2022 GROUP B PUBLIC COMMENT AGENDA

SEPTEMBER 14 - 21, 2022
KENTUCKY INTERNATIONAL CONVENTION CENTER
LOUISVILLE, KY

2022 Public Comment Agenda

Figure 1: Direct-Fastened, Non-Cleated Eave Edge System

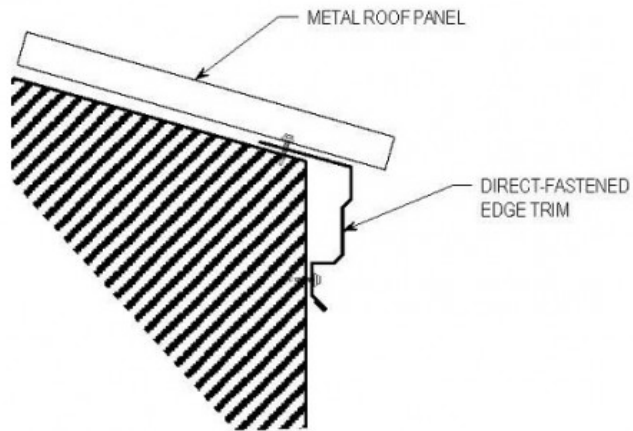
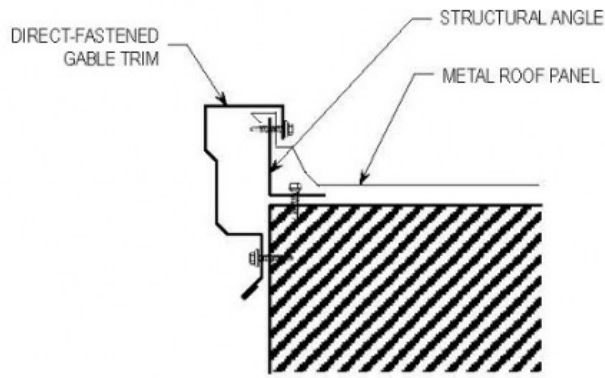
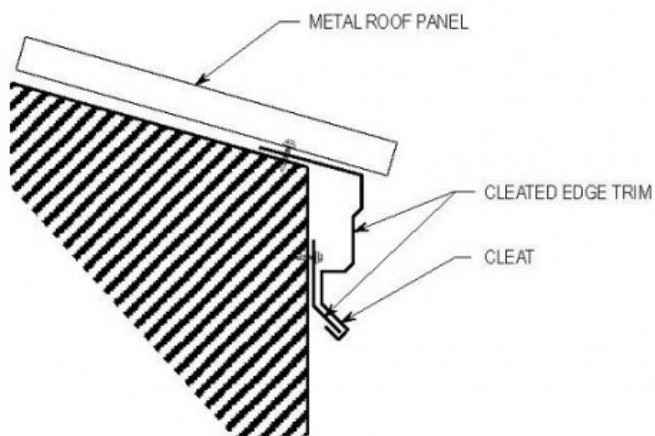
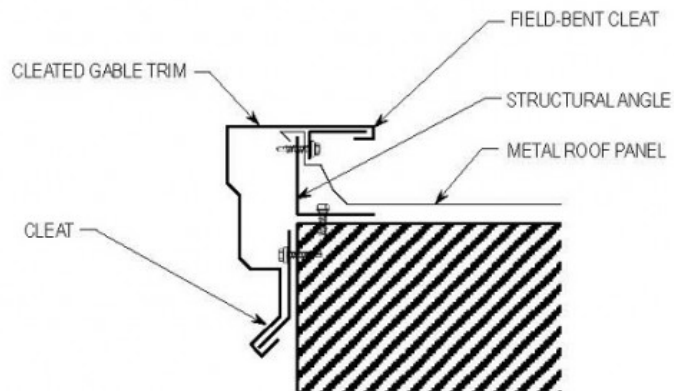
Additional text is also being added to the title of Section 1504.6 to provide delineation between the sections. However, this does not alter the requirements for built-up, modified bitumen and single-ply roof systems in any way.

FIGURE 1 - TOWNHOUSE LAYOUT

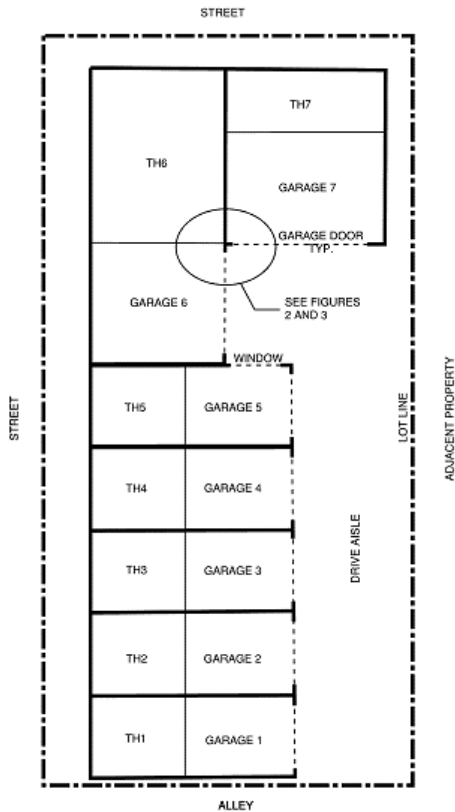
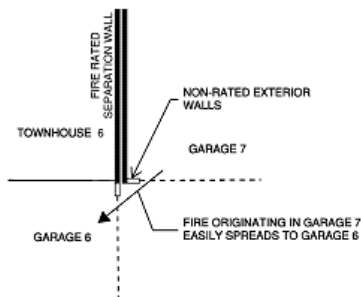
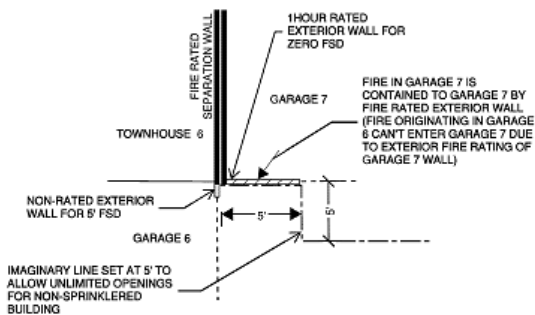
Please support this proposal to bring clarity to the intent of the code regarding exterior walls of adjacent townhouse units.

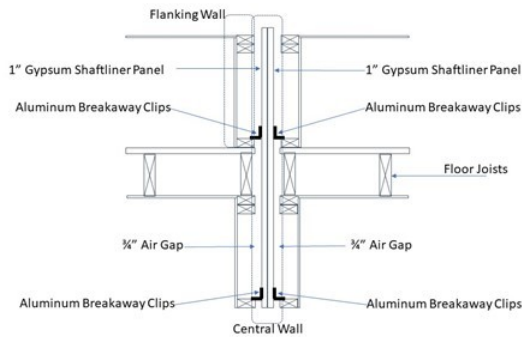
1. Double walls (two 1-hour fire-resistance-rated wall assemblies)
2. A common wall (fire-resistance rated, 1 or 2 hours depending on sprinklers)
3. An "area separation wall" (ASW), consisting of one central two-hour fire-resistance-rated wall with a flanking wall attached with aluminum clips on one or both sides.

For various reasons, each of these options is more common in different regions of the US. #1 and #2 are already addressed in Section R302.2. ASWs are currently being built, but not mentioned in the code. Further clarification is required, particularly with regards to penetrations of the non-rated flanking walls, as some users have believed that the space between the central fire-rated wall and the non-rated flanking walls cannot contain plumbing or mechanical equipment. In fact, an ICC staff interpretation took this position

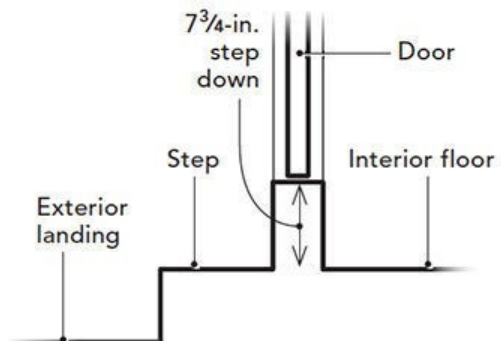
Reason: This proposal started as question – Can the landing or steps into a garage be the same as permitted for exterior doors or not? The following are current requirements - There is a requirement for landings at exterior doors (R311.3) and a requirement for landings at the top and bottom of stairways (R311.7.6). The required egress door has to open directly into a public way, yard or court (R311.1), so it has to be an exterior door. Egress is not permitted through a garage (R311.1).

Interior doors not have requirements for landings, so going out to a single step or multiple steps would be covered by the stairway landing requirement in Section R311.7.6. The current exception clarifies that steps into a garage are considered interior stairways.

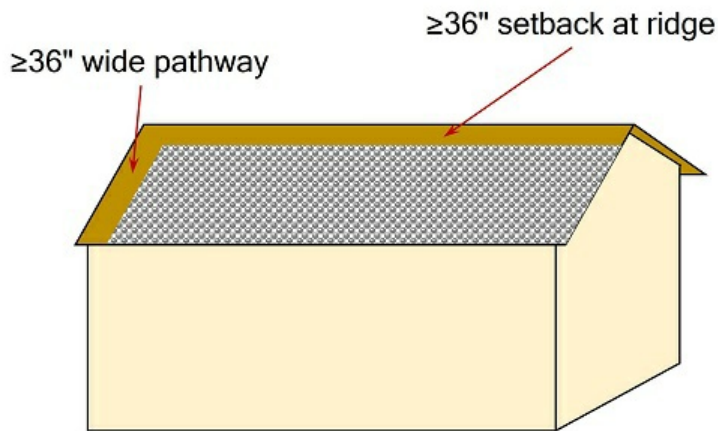
R324.6.1.1 Pathway design. Pathways shall provide access from the lowest roof edge or eave to the ridge and have a minimum width of 36 inches (914 mm). Pathways shall be over areas capable of supporting the live load of fire fighters accessing the roof. Pathways shall be free of conduit, mechanical equipment, skylights, satellite dishes, ventilation hatches or other obstructions that would block the pathway or create a tripping hazard.

FIGURE 1: Sleeping loft in a bedroom (as built)

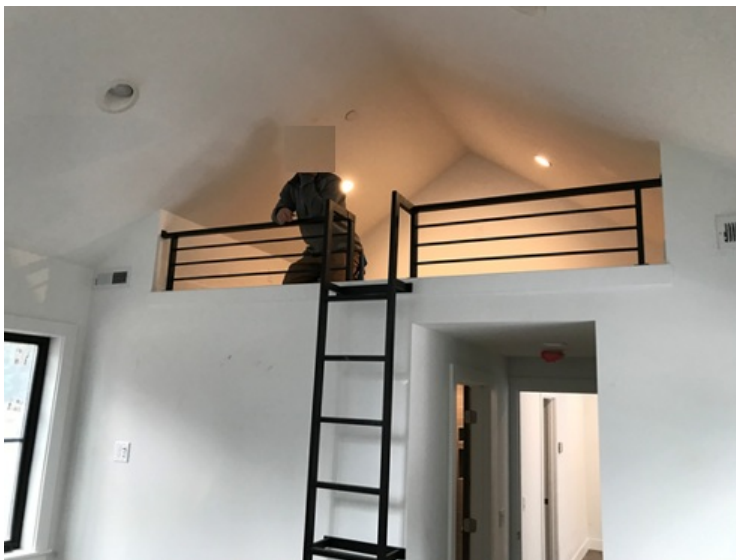
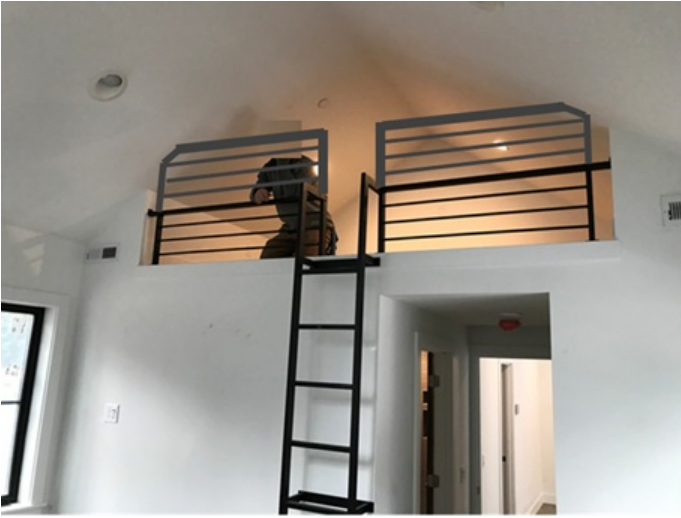
- Sleeping lofts may be confused with mezzanines, so the exception to R325.1 points the user from the mezzanine section to the sleeping loft section.

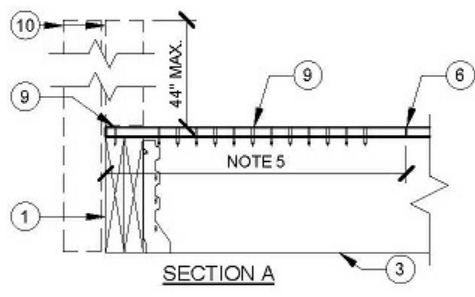
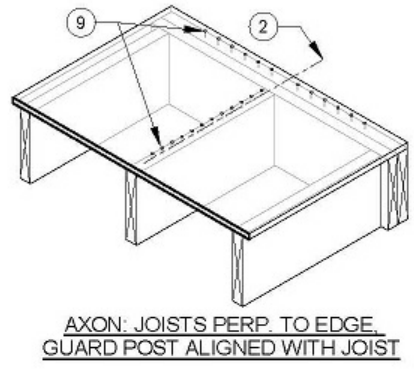
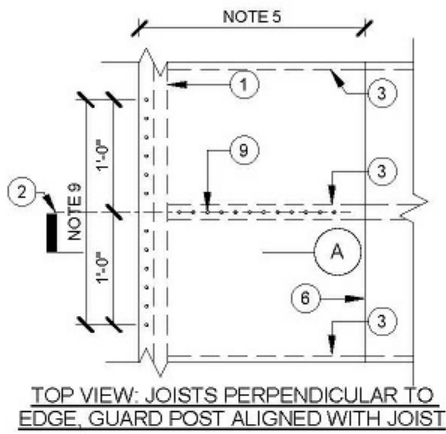
R502.11.3 Roll bracing. Each roll brace shall be a joist or blocking matching the depth of the edge member and extending perpendicular to the edge member a minimum of 16 inches (406 mm) from the edge. Blocking shall have end connections with a minimum of six (6) – 16d common nails. Floor sheathing shall be continuous for a minimum of 24 inches (610 mm) from the edge and shall be fastened to each roll brace with a minimum of twelve (12) – 10d common nails and shall be fastened to the edge member with a minimum of twelve (12) – 10d common nails within 12 inches (305 mm) of the roll brace.

Commenter's Reason: The Committee approved this proposal because it provides a prescriptive solution for floor framing supporting guards that will resist required design loads applied to the top of the guard and **corrects a serious deficit** in the current requirements for floor framing **that void the warranties of engineered floor systems and allows the potential failure of the floor and connected guard assembly/system.** However the Committee specifically requested clarification by public comment. The changes included in this modification are described below. They address not only the Committee's request but also those issues raised in testimony, further collaboration of industry and editorial changes to aid in understanding.

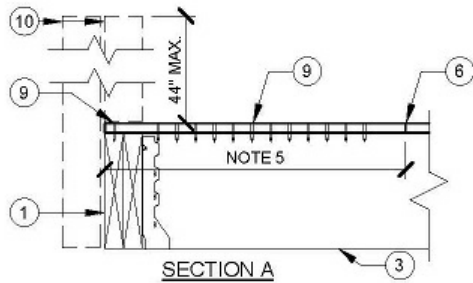
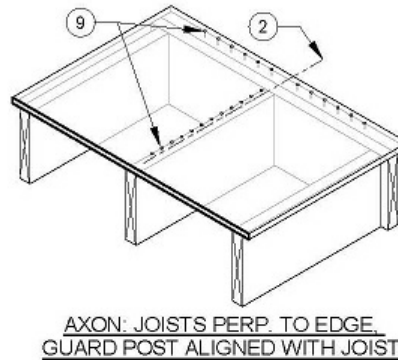
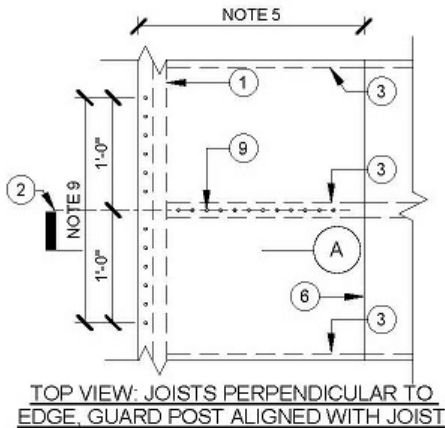
~~502.11.3~~ **R502.11.5 Roll bracing for lumber edge members.** Each roll brace shall be a joist or blocking matching the depth of the edge member and extending perpendicular to the edge member a minimum of 16 inches (406 mm) from the edge. Blocking shall have end connections with a minimum of six (6) – 16d common nails. Floor sheathing shall be continuous for a minimum of 24 inches (610 mm) from the edge and shall be fastened to each roll brace with a minimum of twelve (12) – 10d common nails and shall be fastened to the edge member with a minimum of twelve (12) – 10d common nails within 12 inches (305 mm) of the roll brace.

R502.11.3 Truss edge framing for Top Mount Guard Post. ~~Where trusses are used as the floor edge framing member supporting top mount guards, the truss shall have a double top chord and double 4x2 vertical webs spaced 24 inches (610 mm) o.c. The truss shall have a minimum net width of 3-1/2 inches (90 mm) and a minimum net depth of 12 inches (235 mm) and shall be braced to resist rotation by roll bracing as described in Section R502.11.6 with a roll brace aligned with each guard post or at intervals of 24 inches (610 mm) or less.~~

FIGURE R507.9.2(1) R507.9.1(1) DECK ATTACHMENT FOR LATERAL LOADS

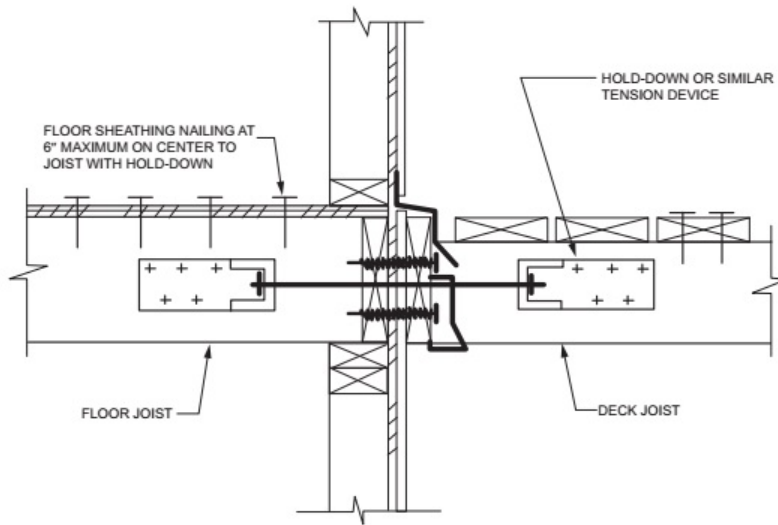
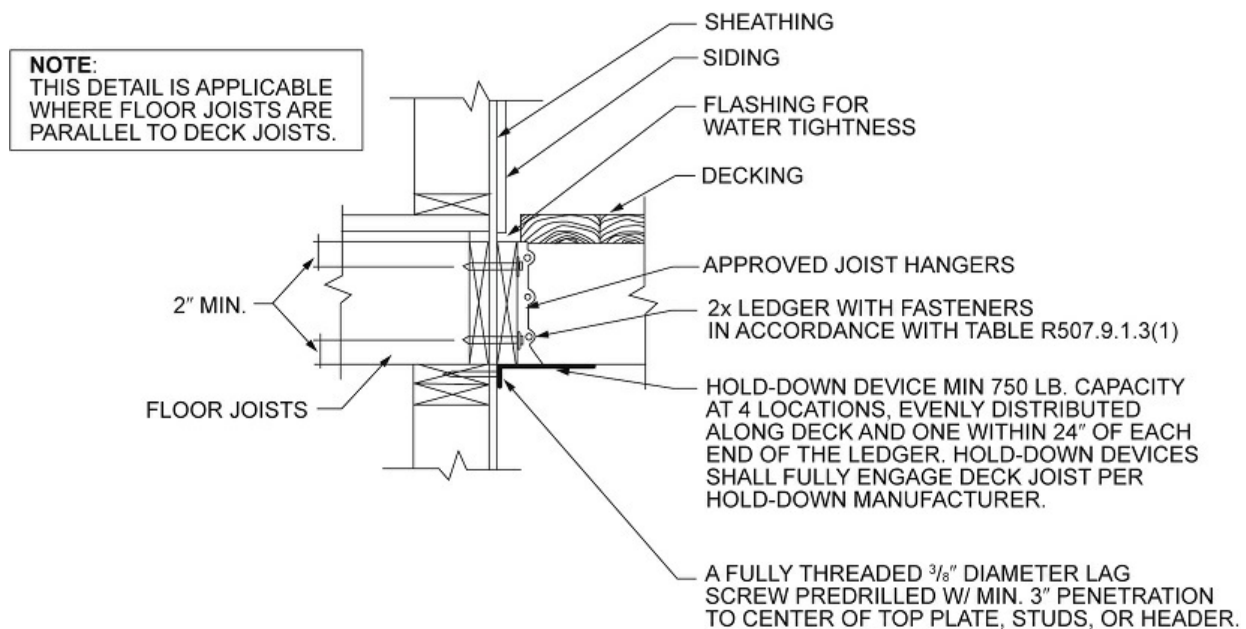
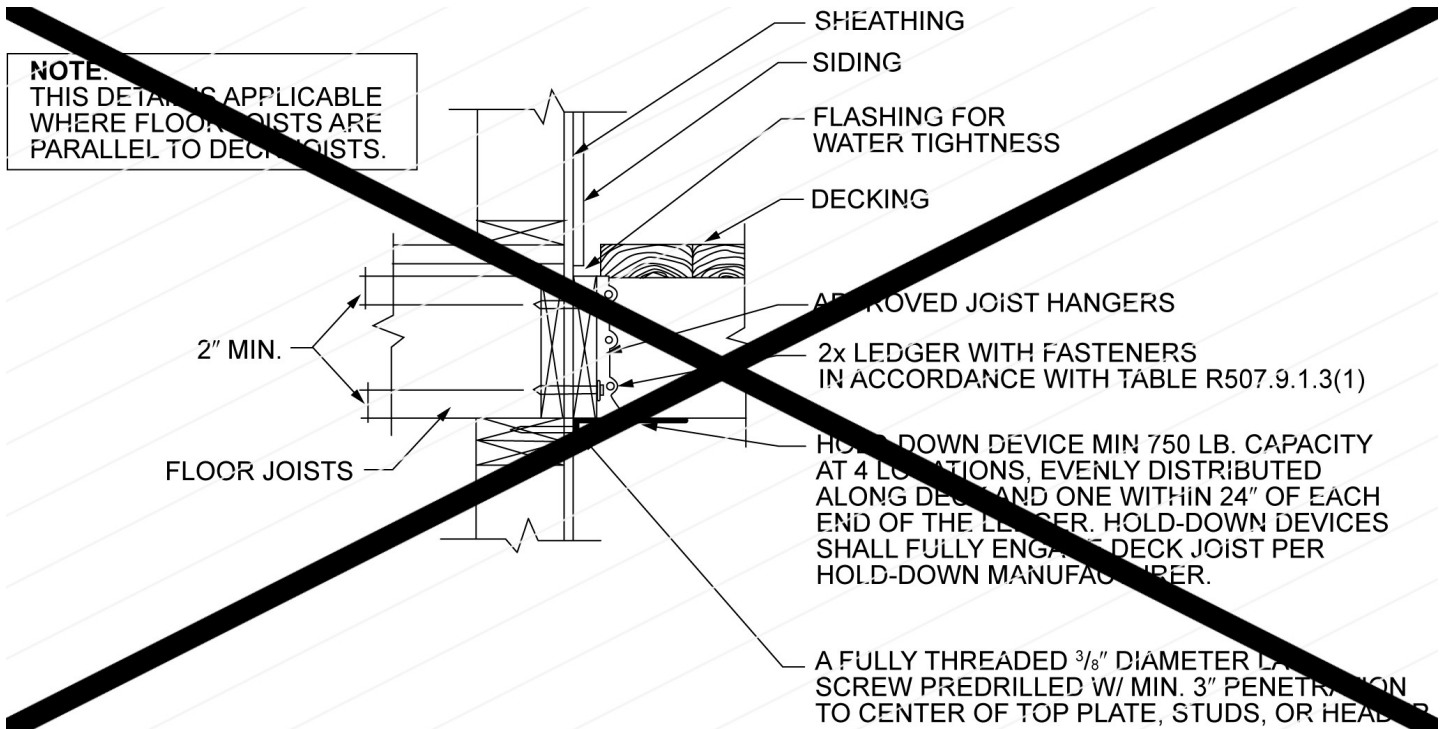
R507.9 Lateral connection bracing. Decks shall be braced against lateral movement in all directions. Lateral bracing perpendicular to a building shall be permitted in accordance with Section R507.9.1. ~~designed to transfer lateral loads to the ground or to a structure capable of transmitting~~

them to the ground. Bracing shall be required in all lateral directions in accordance with accepted engineering practice, utilizing ~~approved braced wall panels, knee braces, cross braces, K braces, moment frame post connections, embedded support posts, horizontal diaphragms, lateral connections in accordance with Section R507.9.1, or through other approved methods.~~

Figure 2 Caption: Parapet bracing and added tension ties to the roof/floor framing. FEMA P-530

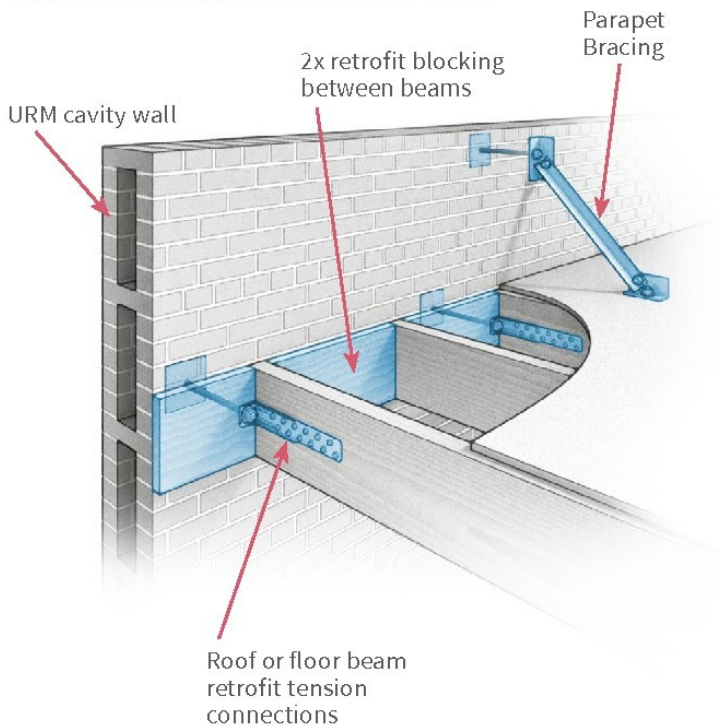
ROOF PARAPET WALL BRACING RETROFIT
